Vietnam Veterans Memorial Center

NCPG Revised Concept Submission April 3, 2009 | POLSHEK PARTNERSHIP ARCHITECTS

I. National Capital Planning Commission ACTION & COMMENTS

NCPC File No. 6597

2009 REVISION - Site Plan

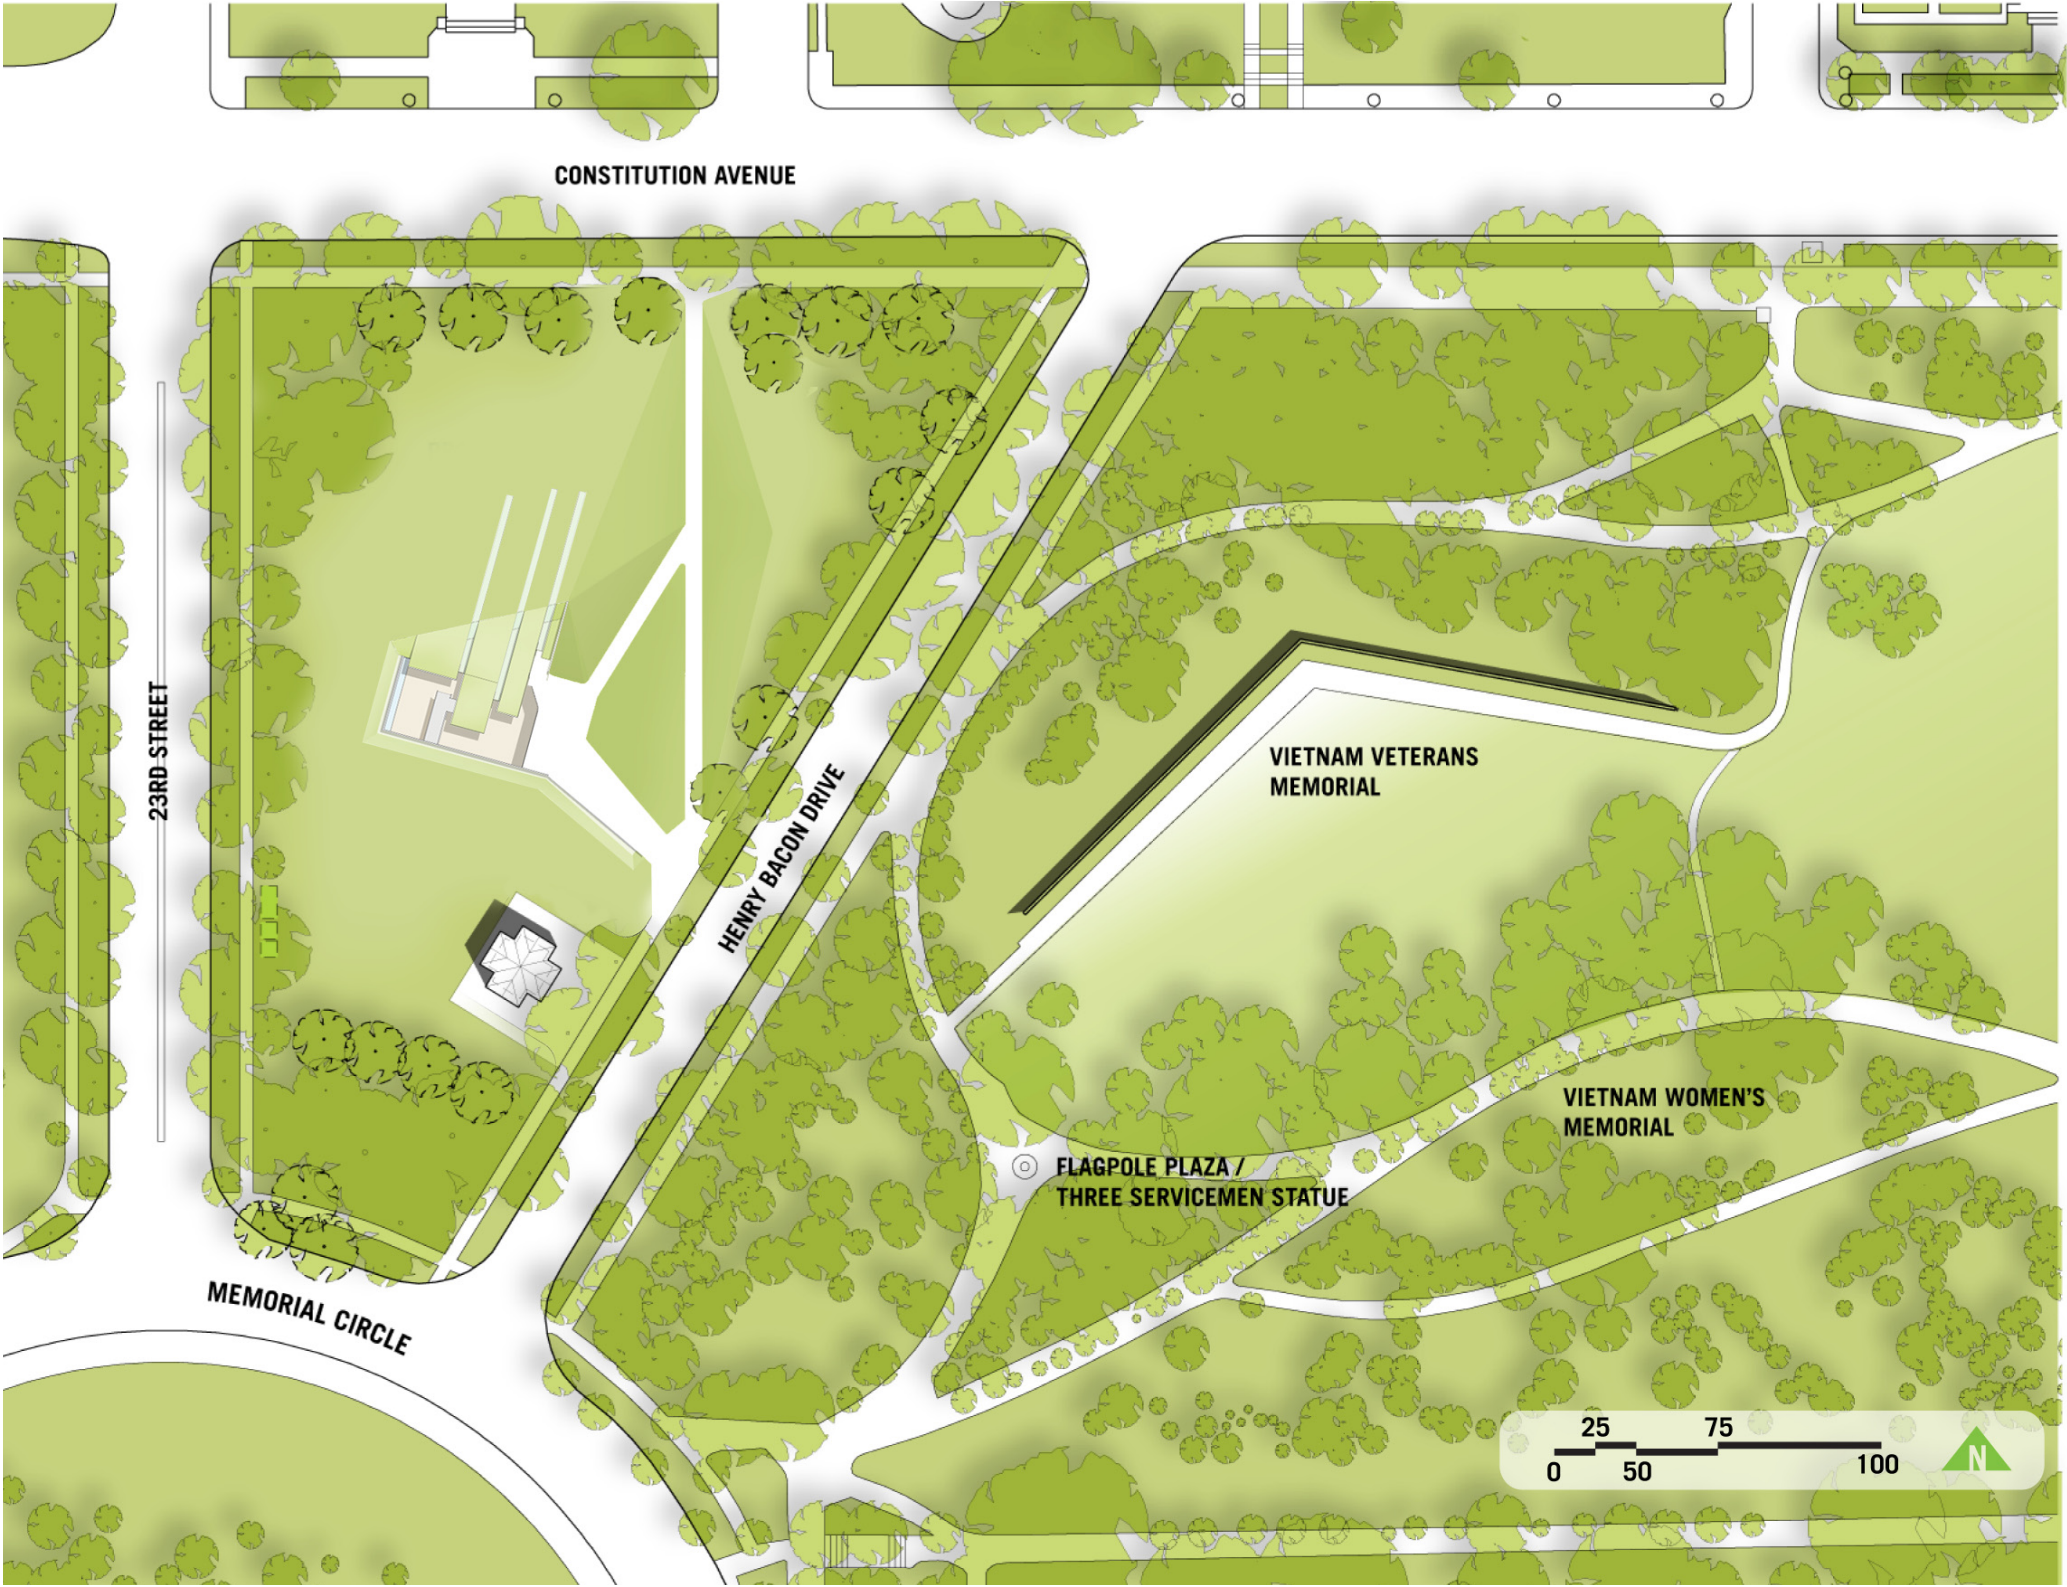
A. Siting and Grading – The design team proposes that raising the elevation of the existing grade approximately 42” above its current level mitigates several concerns about the Center. First, a slight raise in grade reduces the overall vertical travel required from the perimeter sidewalks of the site, and therefore reduces the required overall approach ramp length. The reduced ramp length, in turn, permits several other improvements to occur:

1. a simpler ramp configuration that relates to the site’s geometry
2. an adjustment of the building siting further to the north which creates a better relationship to the existing National Park Service Concession Kiosk as well as to the perimeter tree root zone
3. an adjustment of the building siting that is now axial to the centerpoint of the Lincoln Memorial
4. an adjustment of the site stair, which is now axial to the Vietnam Veterans Memorial flagpole across Henry Bacon Drive
5. a more substantial berm along the east face of The Center which reduces the overall area of visible façade.

Furthermore, a slight raise in grade reduces the overall visibility of The Center by reducing the sight lines from various vantage points along the perimeter sidewalks of the site.

REVISED ROOF PLAN

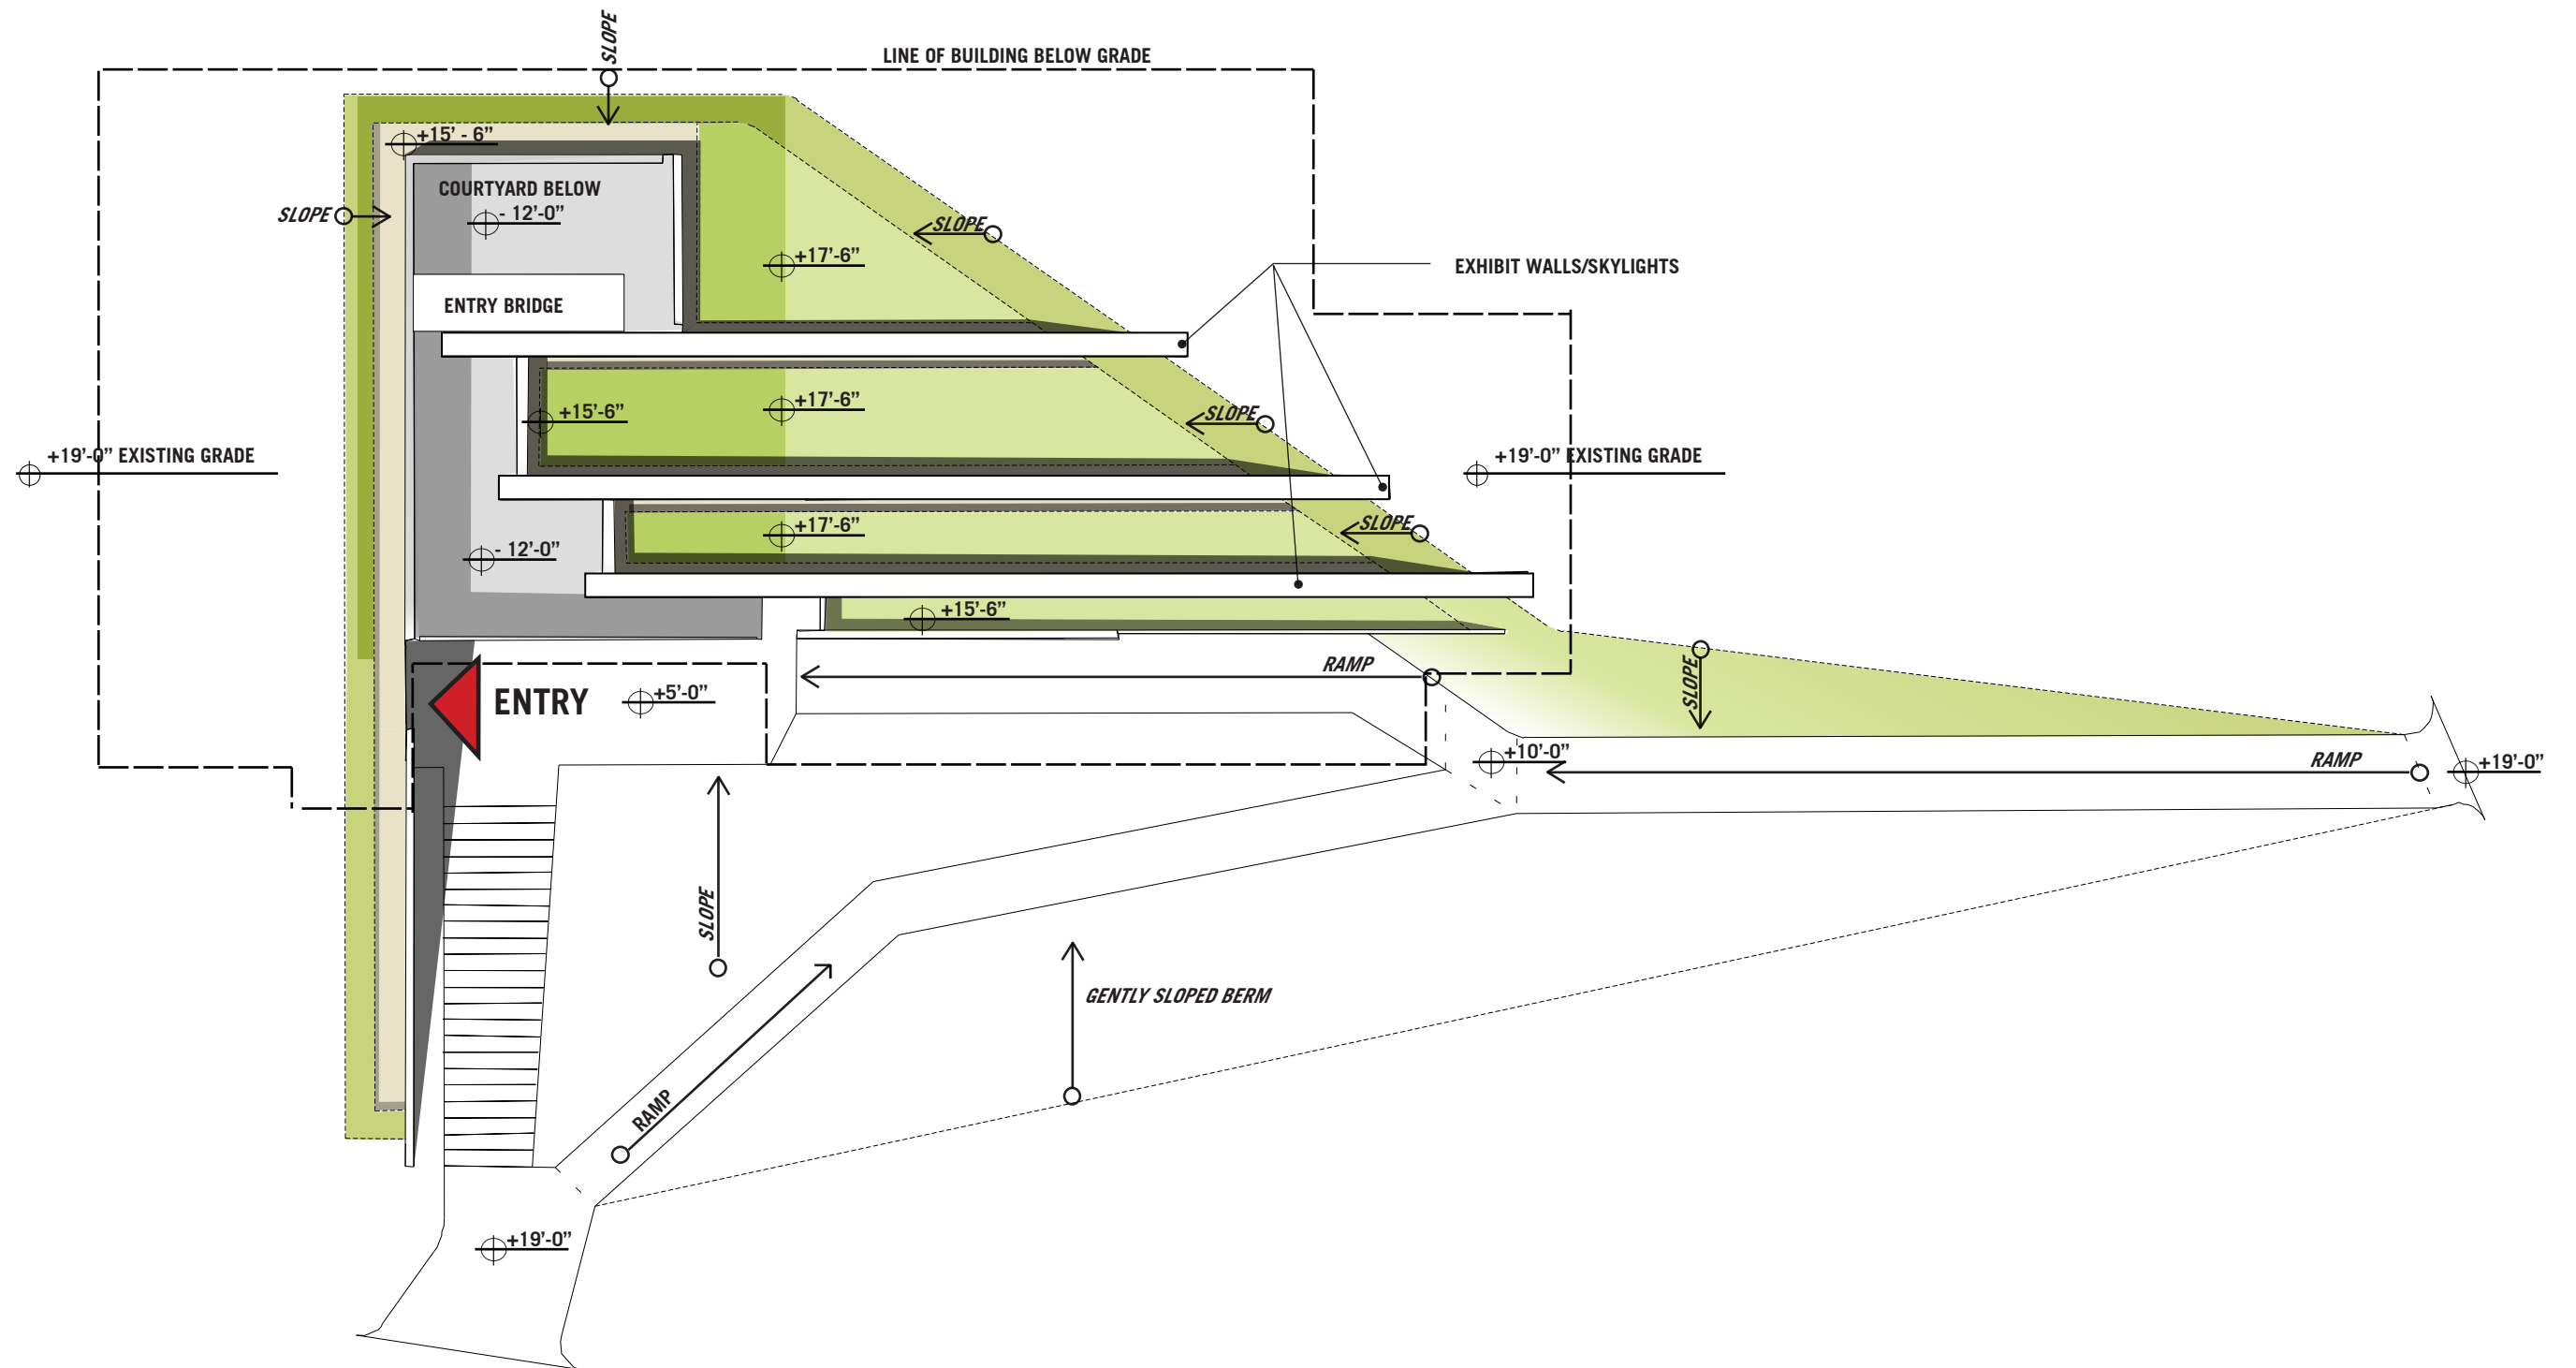
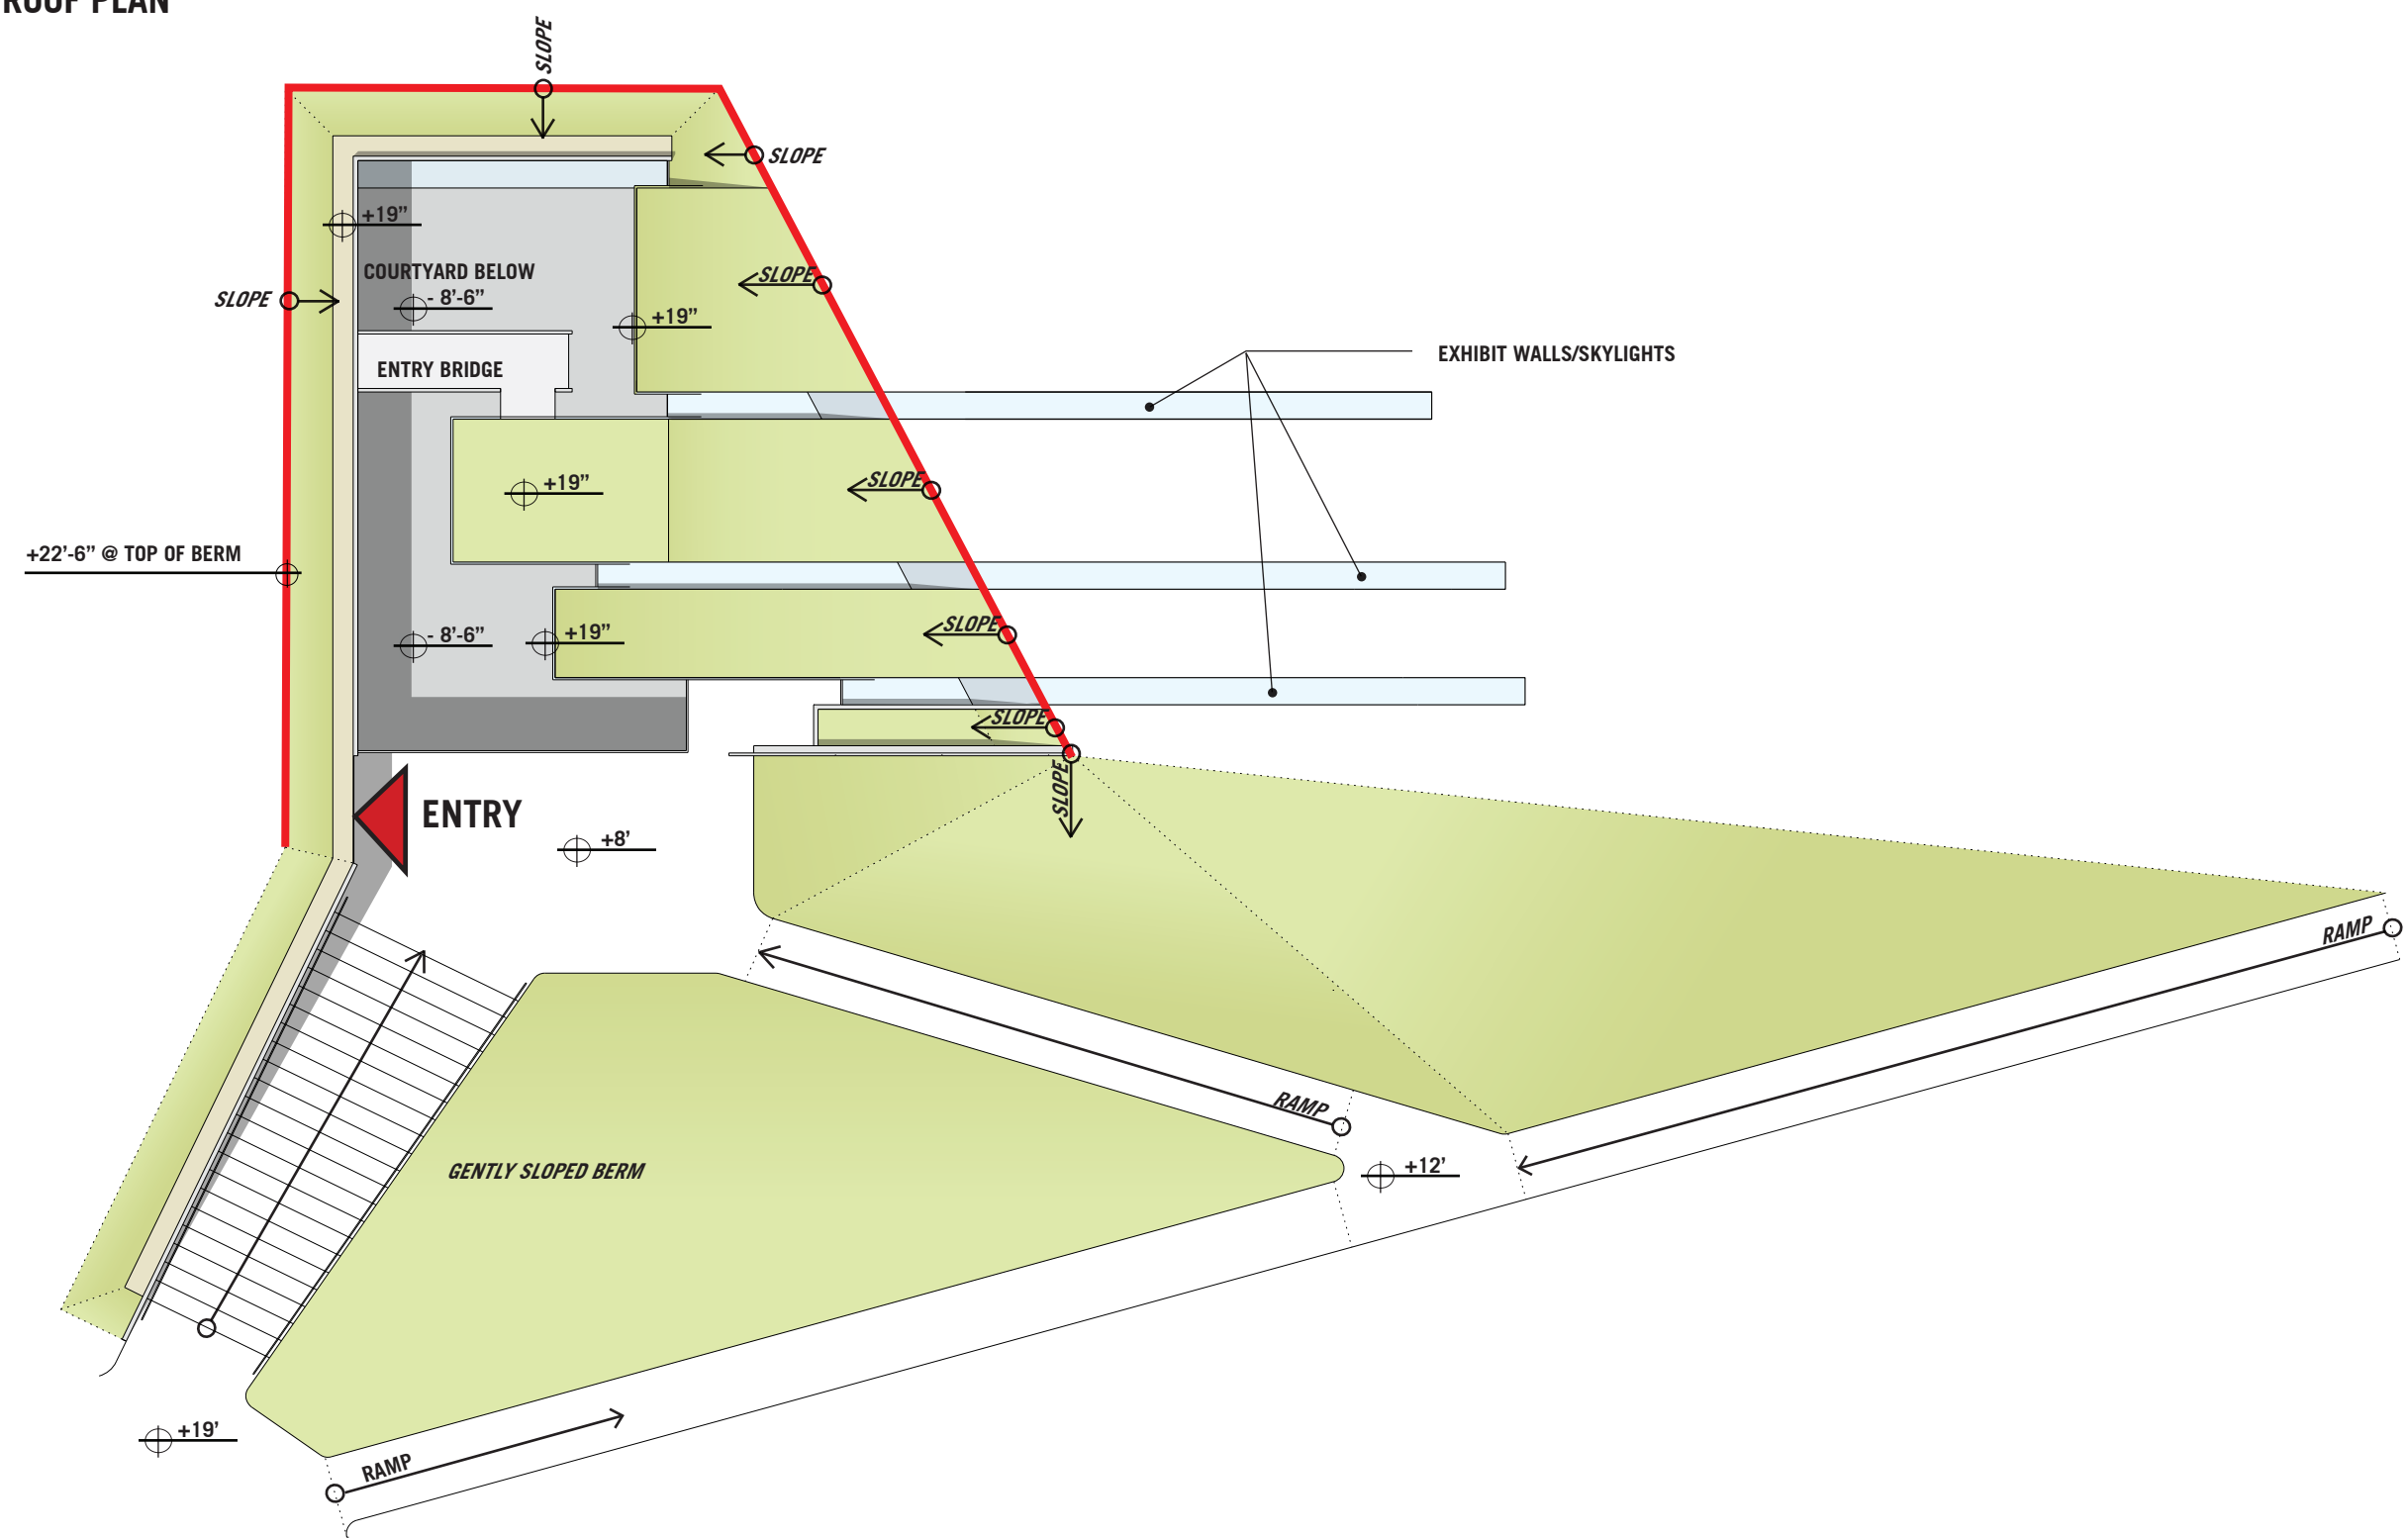
1. The exhibit wall skylights have been pulled down in section so that they are flush with the adjacent grade instead of protruding above the adjacent grass level. Consequently, there are no longer protruding volumetric skylight elements.

2. The exhibit walls have been pulled back in plan so that they no longer protrude into the courtyard. This reduces the overall scale and area of the building’s visible façade and vertical surface.
